CITY OF YPSILANTI
Agenda
Historic District Commission
Tuesday, July 24, 2018 - 7:00 p.m.
City Hall, Council Chambers, 1 S. Huron
Ypsilanti, MI 48197

HDC Work Permit Staff Review

Property address: 214 N River

Property address: 322 Maple

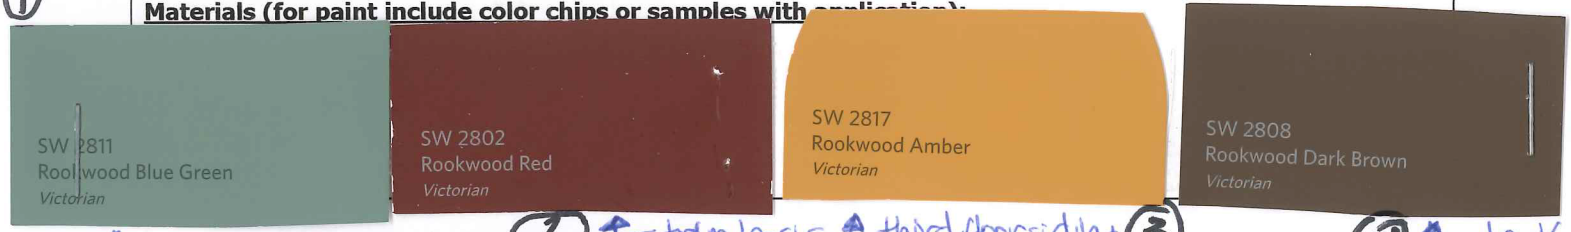
1. The applicant is looking for approval for painting.
2. The applicant plans to use the Rookwood Blue Green as the main color, the Rookwood Red for the trim/posts, the Rookwood Amber for the third story scalloped shaped siding and the Rookwood Dark Brown for the deck and porch.
3. The applicant plans to paint the main house and the garage.
4. The applicant does not plan to power wash but to scrape and caulk in preparation for painting.
5. A building department permit will not be required for painting.

Recommended Motion:
Move to approve the work at 214 N River to include the painting of the house and garage in Sherwin Williams 2811-Rookwood Blue Green for the main color, Sherwin Williams 2802-Rookwood Red for the trim and posts, Sherwin Williams 2817-Rookwood Amber for the third floor scalloped shaped siding and Sherwin Williams 2808-Rookwood Dark Brown for the deck and porch.
